GENERAL ELECTRIC COMPANY, 41 WOODFORD AVENUE, PLAINVILLE, CONN. 06062

AKR-30 AND AKR-50 ELECTRICALLY OPERATED
LOW-VOLTAGE POWER CIRCUIT BREAKERS

SERVICE ADVICE

Subject: Instruction for Replacement of Switchette on AKR 30/50
 Electrically Operated Circuit Breakers

Procedure 82-1
 Rev. 0
 Page 2 of 2
 Drawing #139C4619

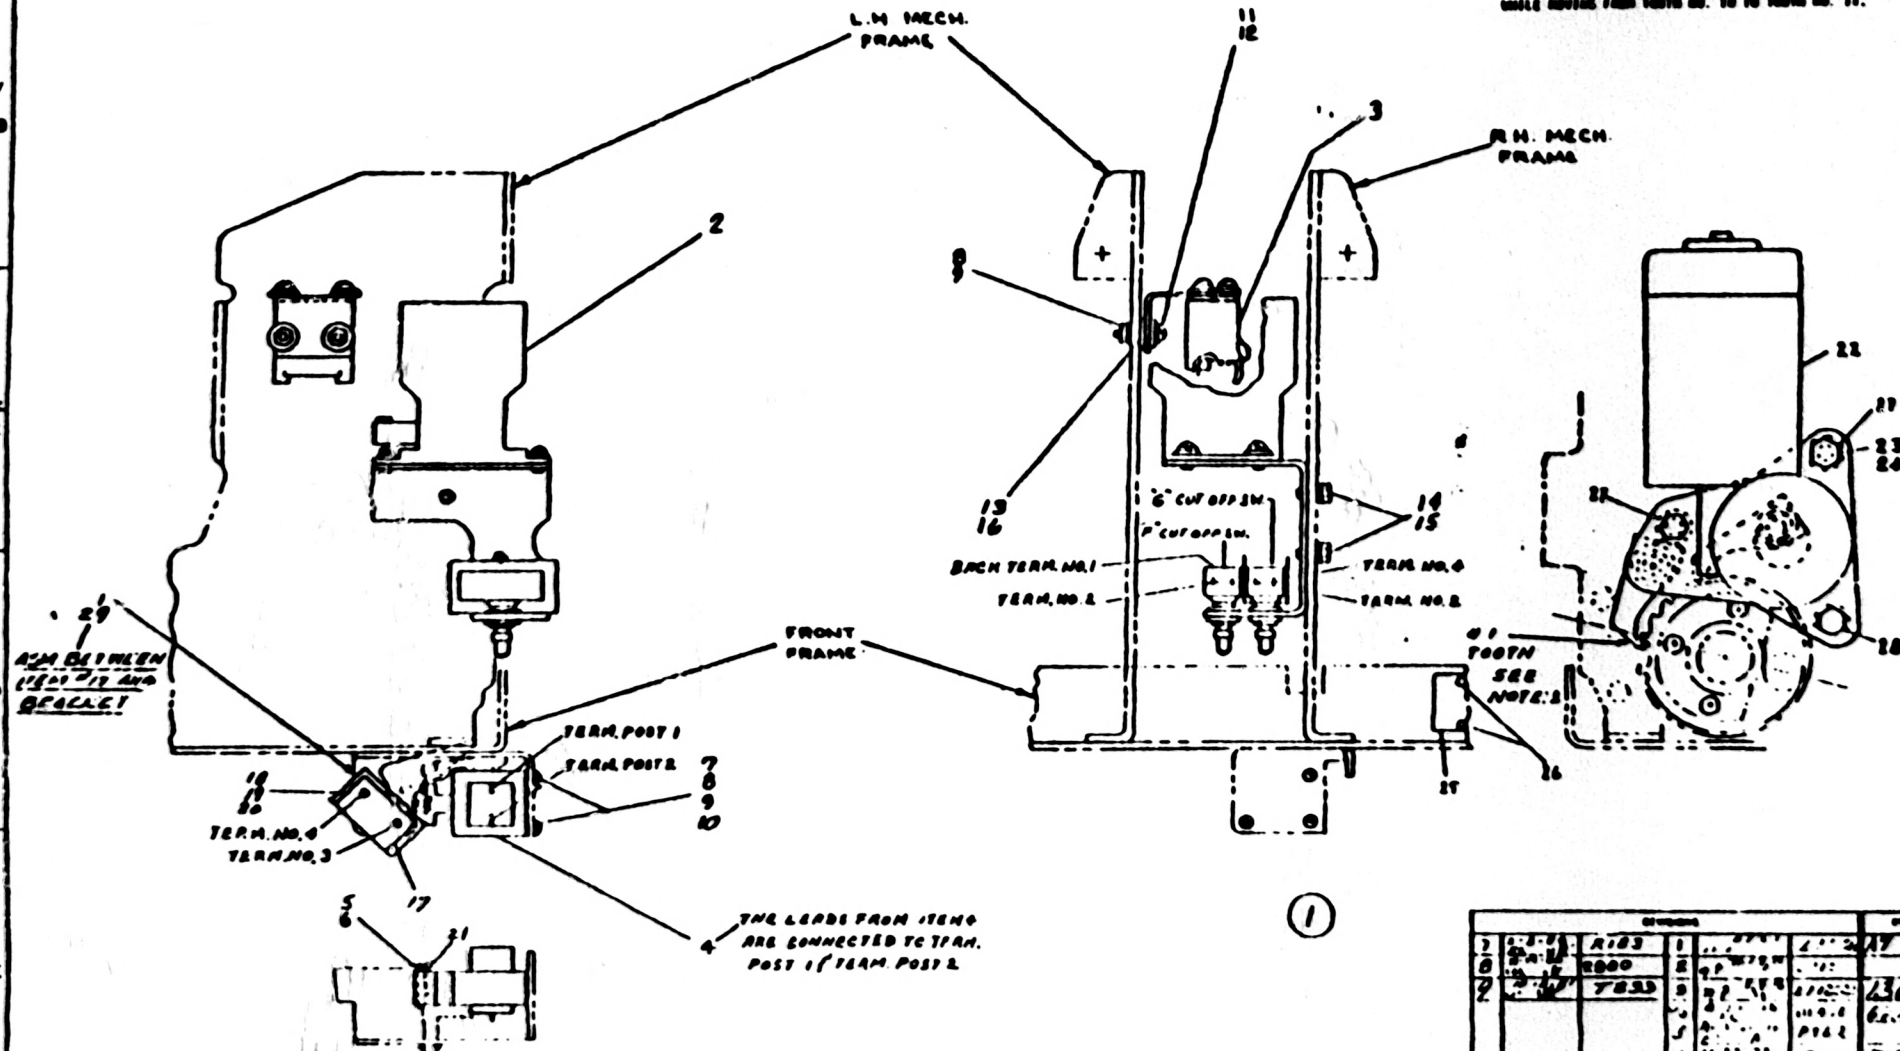
SEQUENCE	OPERATION/EXAMINATION OR TEST	PRODUCTION INITIAL/DATE	QUALITY INITIAL/DATE
1	See attached drawing (139C4619). Remove the switch (P17) from the bracket by removing the two round head screws (P18), lockwashers (P19), and nuts (P20).		
2	With switch dismounted, disconnect leads (Terminal Post 3 and 4) to its terminal.		
3	Install replacement switch care- fully pushing towards the link which operates it.		* _____
4	Install screws, lockwasers, nuts (P18, P19 and P20) and fully tighten to approximately 10 inch pounds to insure reliable opera- tion.		* _____
5	Check the continuity of the switch using an appropriate detector while pushing the closing solenoid armature closed.		* _____

Fig. 3

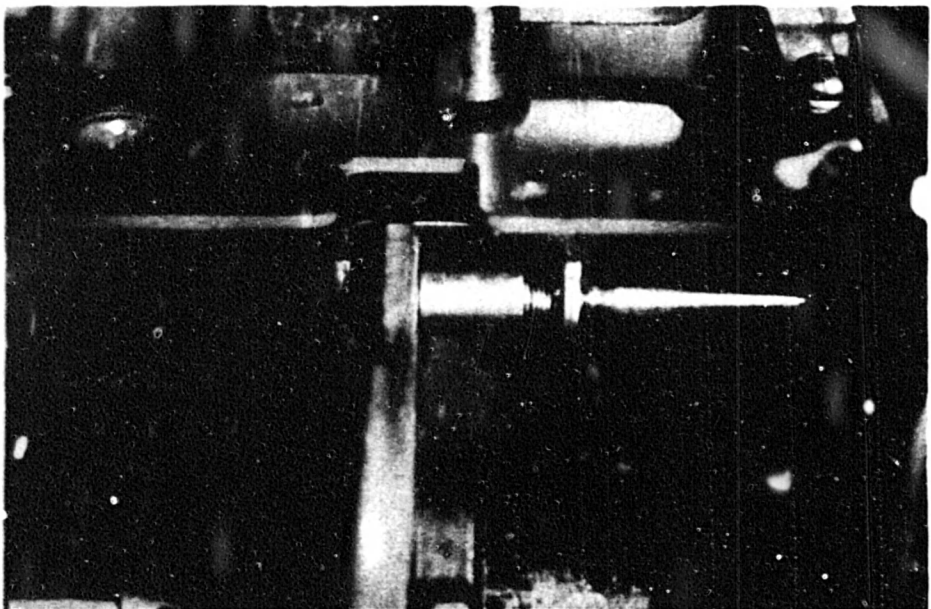
SEQUENCE	OPERATION/EXAMINATION OR TEST	PRODUCTION INITIAL/DATE	QUALITY INITIAL/DATE
9	See photograph, Figure 3. Remove retaining ring from right end of pin which supports the closing spring prop.		
10	See photograph, Figure 4. Drift pin to the left until the prop is free and remove it.		*
11	See NOTE. As pin is moved back to its normal position, the components should be placed on the pin in the sequence of new prop, torsion spring, large spacer, and then the small spacer on the outside of the mechanism side place.		
NOTE The replacement of the torsion spring can be made easier by tying the partially wound spring with string as shown in <u>Figure 5</u> . After it is in place on the pin, the string may be cut and removed.			*
12	Reassemble the other dismounted components in the reverse order of their removal.		*
* Indicates verification inspection required.
